Planning Proposal – Consideration and required amendments

Recommendation for zoning amendments to the Planning Proposal

Figure 1:
Recommendation for zoning amendments to the Planning Proposal

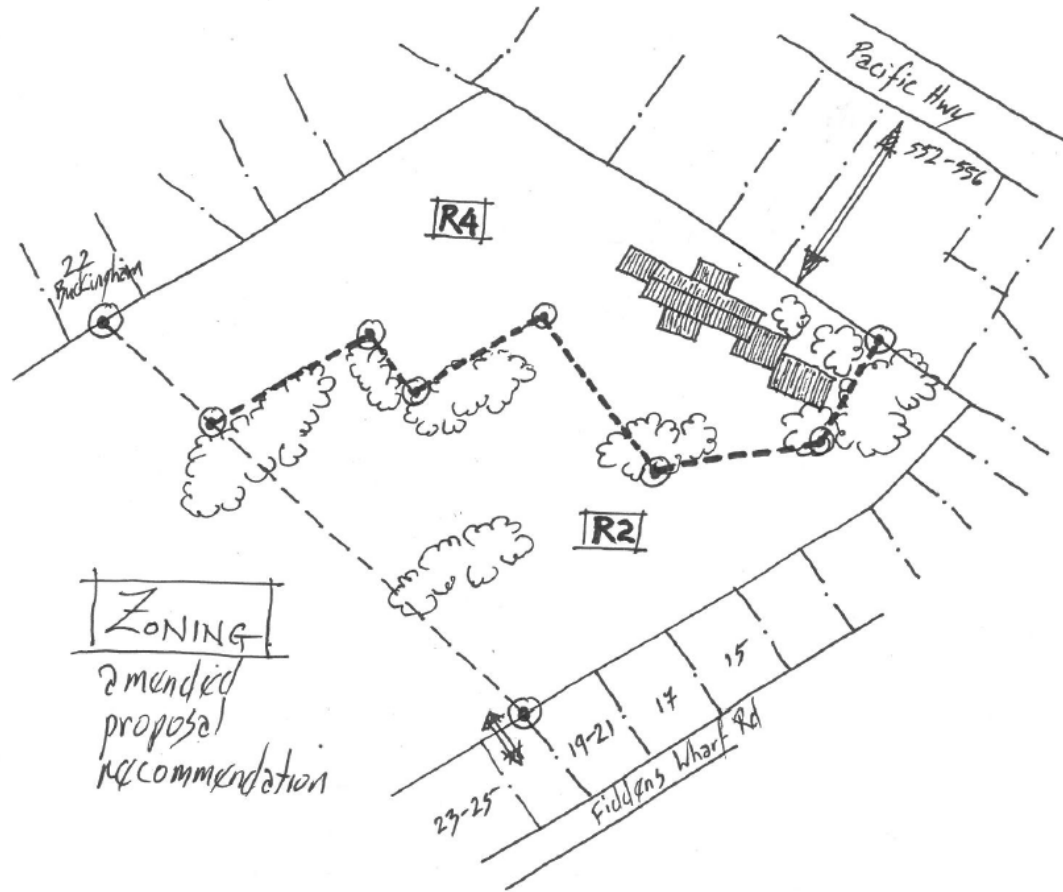
10	3.0 Description of the proposal <i>Item name</i>	The item name doesn't fully describe the elements and curtilage identified as significant.	<ul style="list-style-type: none"> Revise the Heritage Item name in Schedule 5 to: <i>Killara Golf Course Clubhouse including putting green and fairway.</i>
12	4.0 Assessment of heritage impact Storeys of buildings in R2 zone	The HIS states that the R2 zone permits buildings of approximately 3 storeys. Council's preference as stated in the KDCP 2016 (4C.1.1) in an R2 zone is for 2 storeys: <i>The maximum height of a dwelling is 9.5m (including any garage, basement or the like) and present as a 2 storey dwelling house</i>	<ul style="list-style-type: none"> Remove the reference to 3 storeys.
13	4.0 Assessment of heritage impact Impact on 22 Buckingham	<p>The limited inventory sheet for 22 Buckingham Road available for this assessment does not elaborate on the significance of the house to facilitate the assessment of important views and vistas, and how the design of the original house responded to the existing golf course. As such it is difficult to understand the impact of future development under the proposed zoning on the significance of the item other than at a superficial level.</p> <p>Council's practice to protect the significance of Heritage Items, including their amenity to support the traditional and existing use, is to provide compatible and interface zoning. As such 5-storey R4 zoning would not be recommended abutting an R2 (Low Density Residential) zoned Heritage Item.</p> <p>Due to the significant fall from 22 Buckingham Road to the golf course, a higher building height and residential density than that specified in the R2 (Low Density Residential) zone can be accommodated before this amenity is compromised. As such a reduced maximum building height is recommended next to the retained R2 (Low Density Residential) zoned Heritage Item to optimise development potential.</p>	<ul style="list-style-type: none"> See recommended changes to zoning, height boundary lines in the Planning Proposal recommendations (see Figures 1 and 2).

Recommendation for height amendments to the Planning Proposal

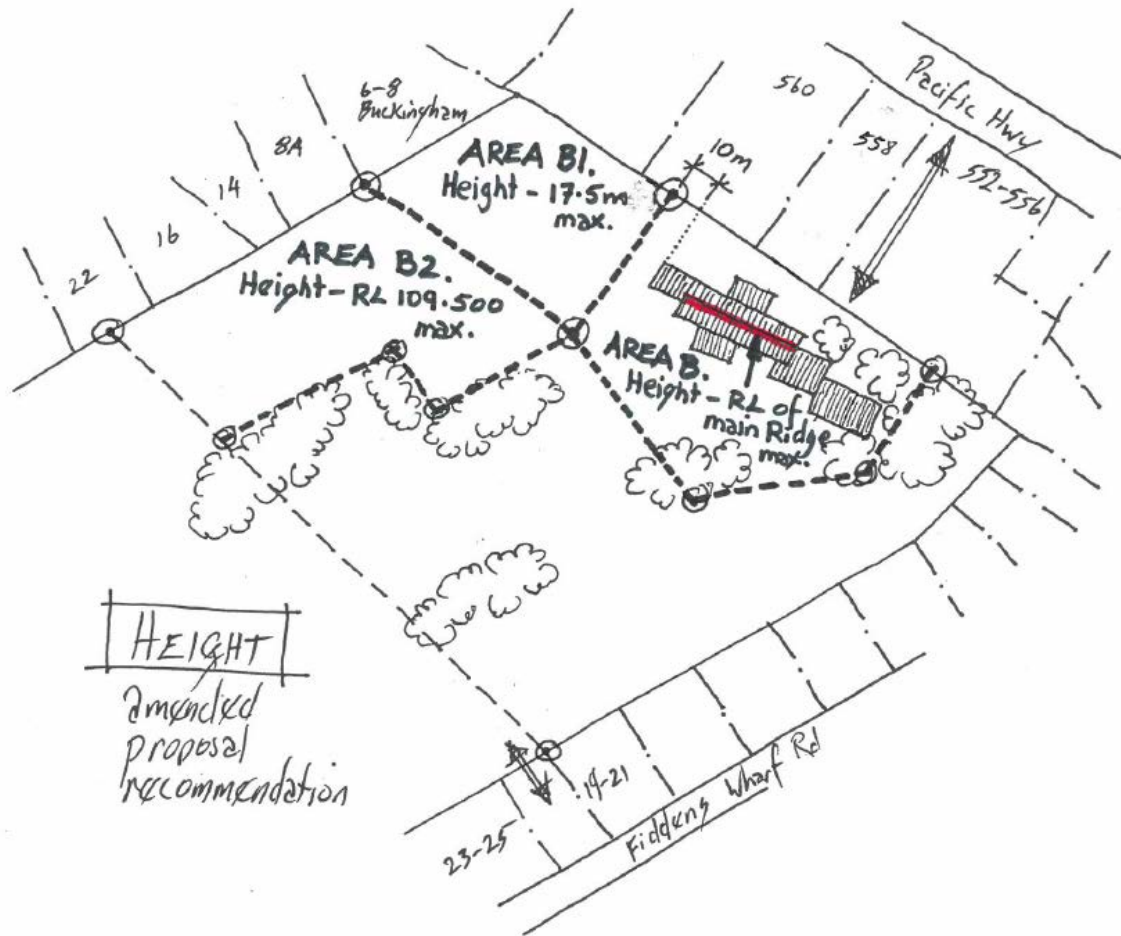
<p>new onsite dwellings, and consideration of the users of the golf course, landscape screening, access and circulation. The planning proposal should include reference to the preparation of site specific DCP proceed provisions as a means of ensuring the delivery of intended outcomes of this Planning Proposal.</p>	
<p>7-8</p>	<p>Part 2 – Explanation of Provisions</p> <p><i>Zoning map</i> <i>Building Height map</i></p>	<p>The objective of the heritage listing is to conserve the heritage significance of the Heritage Item, including curtilage.</p> <p>The objectives of the R4 (High Density Residential) zoning are:</p> <ul style="list-style-type: none"> • <i>To provide for the housing needs of the community within a high density residential environment.</i> • <i>To provide a variety of housing types within a high density residential environment.</i> • <i>To enable other land uses that provide facilities or services to meet the day to day needs of residents.</i> • <i>To provide for high density residential housing close to public transport, services and employment opportunities.</i> <p>The proposed zoning of the Heritage Item as R4 does provide adaptive reuse opportunities but it also creates a conflict in that an adopted new zone implies a defacto acceptance of possible future development or redevelopment consistent with permissible uses in the zone under the LEP, and that any compromise to the significance of the Heritage Item as result of this use must have been considered during the rezoning.</p> <p>However, in this instance the R4 (High Density Residential) zoning is the zoning-through of a Heritage Item which allows development in the vicinity of the item that does not impact on the item’s significance and allows for the offset of development potential (eg. the FSR is calculated for the whole R4 site not just the area free of constraints and available for redevelopment.)</p> <p>To mitigate against any future assumptions that high density residential development is supported within the immediate curtilage of the Heritage Item it is recommended the permissible Maximum Building Height within the area identified in the Conservation</p>	<ul style="list-style-type: none"> • The permissible Maximum Building Height within the area identified in the CMP (page 74) as ‘curtilage A’ be limited to an RL equivalent to the main roof ridgeline (running NW-SE) of the clubhouse (see Figure 2).

Management Plan (CMP) (page 74) as Curtilage A be limited to an RL equivalent to the main roof ridgeline (running NE-SW) of the clubhouse. This potentially permits adaptive reuse of the clubhouse while not supporting 5-storey development within the immediate curtilage of the Heritage Item.	
8-9	Part 2 – Explanation of Provisions <i>Zoning Map</i>	<p>The north-west corner of the proposed R4 (High Density Residential) zone abuts an existing R2 (Low Density Residential) zoned area which includes the Heritage Item I257 at 22 Buckingham Road Killara. To have R4 (High Density Residential) immediately adjacent to an R2 (Low Density Residential) zoning creates an interface issue. It is Ku-ring-gai Council’s practice to generally (where possible) step down the built form bulk and scale through appropriate transitional zoning or height/FSR standards within an interface sites to reduce amenity impacts such as overshadowing and loss of privacy that result from R4 5-storey buildings being adjacent to R2 (Low Density Residential) 2-storey buildings.</p> <p>Limiting the Maximum Building Height of the site immediately adjacent the Heritage Item to RL109.5 will ameliorate some of the impacts from having an incompatible zoning immediately adjacent to the Heritage Item at 22 Buckingham Road.</p>	<ul style="list-style-type: none"> • Reduce the Maximum Building Height of the site immediately adjacent the Heritage Item at 22 Buckingham Road Killara from an RL of 109.810 to 109.500 (see Figure 2).

<p>Area B2: As indicated in the section drawing on pg 26 and 27, the proposed height of RL 109.810 would result in a building that would be 1.76m above the balcony floor RL108.050 at 14 Buckingham Rd, and 0.93m above the balcony RL108.880 at 8A Buckingham Rd. No indication has been given regarding the relative height to indoor and outdoor living areas on 22 Buckingham Rd (Heritage Item) and 16 Buckingham Rd.</p>	<ul style="list-style-type: none"> • To incorporate an Interface Area, adjust the boundary line of the Area B2 with maximum Height to RL 109.500 from the corner boundary point between 8A Buckingham Rd and 6-8 Buckingham Rd to the corner point of the Heritage Curtilage Area and the Heritage Visual Curtilage lines (see Figure2), and accurately plotted
